NLR Planning Commission - UPDATED
October 13, 2020
Agenda Meeting / Public Hearing 4:00 PM

SD2020-45 Tom Salmon Subdivision, Lot 1 (Site Plan Review of a car wash at 4315 McCain Blvd)

1 Site Plan-Overall Concept
SCALE: 1/8" = 1'-0"

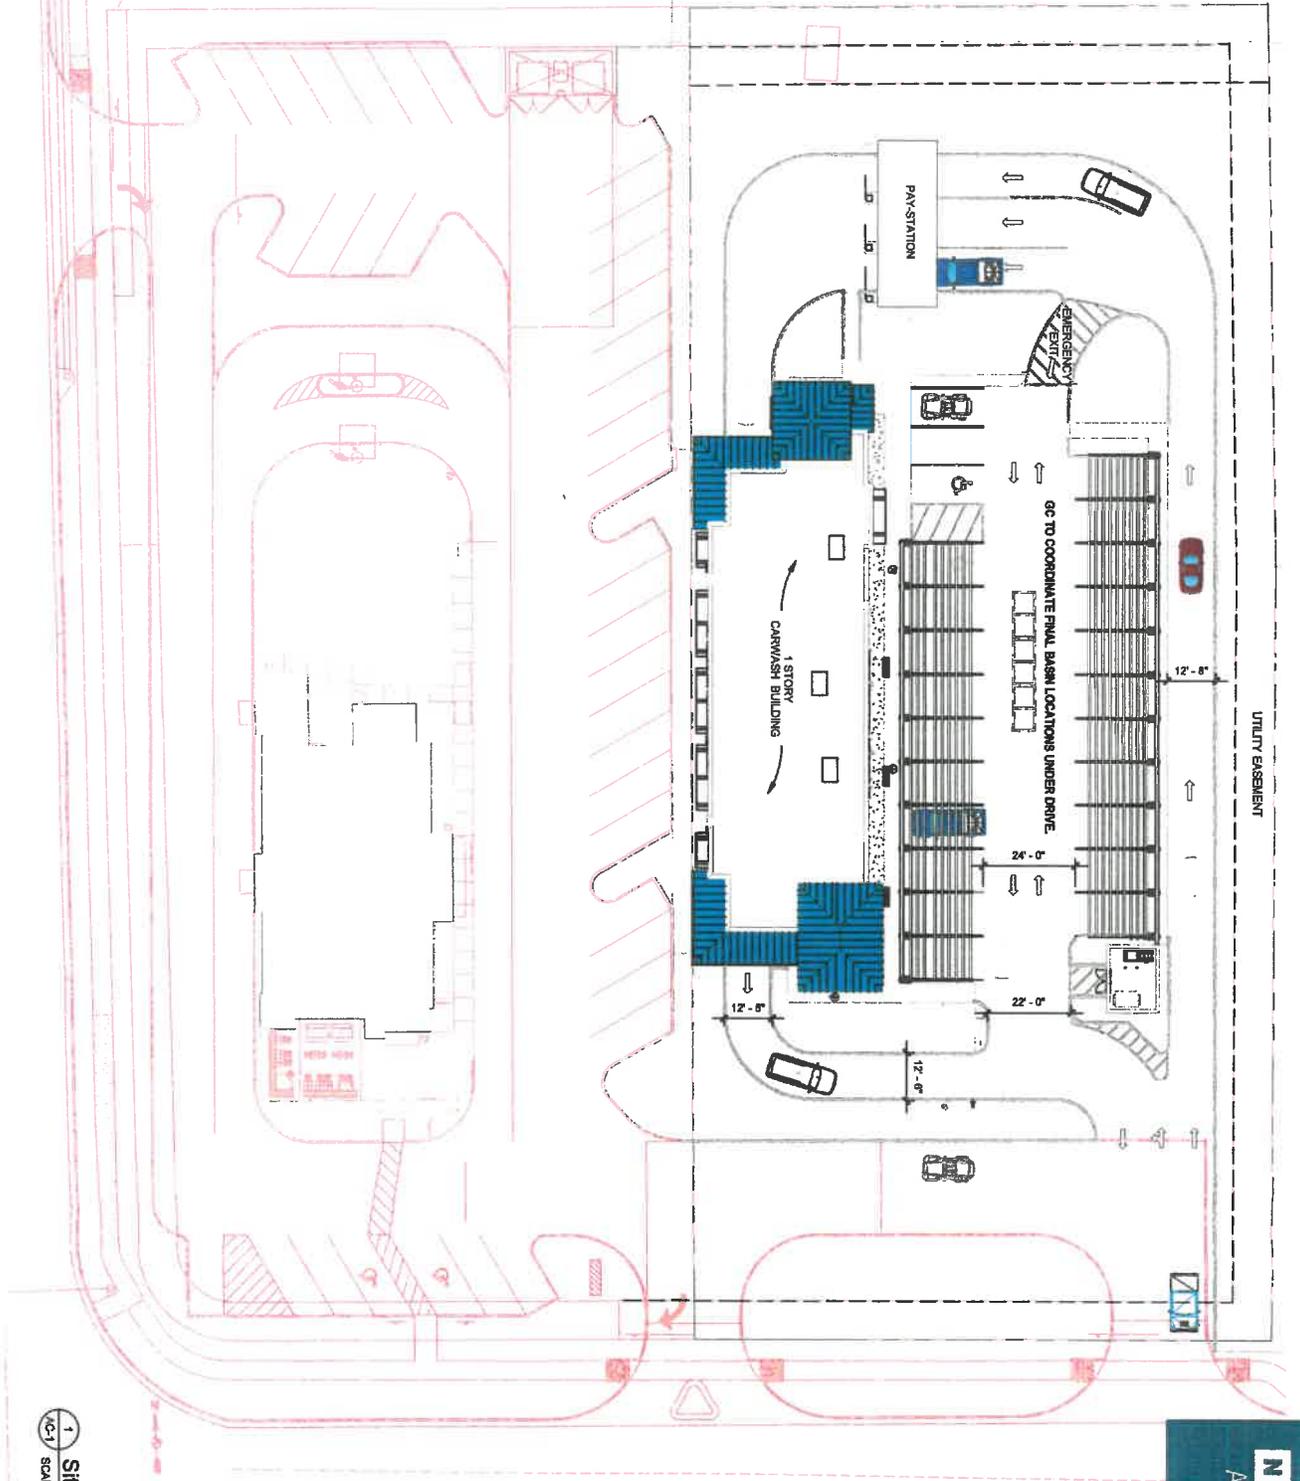
- 1. Before applying for a building permit, provide City Council Ordinance approving a Conditional Use for a car wash.**
- 2. Permit requirements/approvals submitted before a building permit will be issued:**

- a. Option to pay the drainage in-lieu of fee of \$5000/acre instead of providing onsite detention.
 - b. A signed and recorded plat must be on file with the Planning Department.

- 3. Meet the requirements of Community Planning, including:**
 - a. Provide the standard requirements of Zoning and Development Regulations.
 - b. No building can encroach into an easement.

- c. Provide dumpster location.
 - d. Dumpster to have masonry screening.
 - e. No fence is to be within a front building line.
 - f. All exterior lighting shall be shielded and not encroach onto neighboring properties.

- 4. Meet the requirements of the Master Street Plan, including:**
 - a. Provide 5' sidewalks and ramps with a minimum of 5' green space between sidewalk and curb to ADA standards and City standards.

- b. Provide automated underground irrigation to all required trees and shrubs.
 - c. Provide 3 street trees along McCain Blvd.
 - d. Provide 4 parking lot shade trees.

- h. Provide 6 foot front yard landscape strip between property line and paving.
 - i. Provide 4 foot side yard landscape strip between property line and paving.
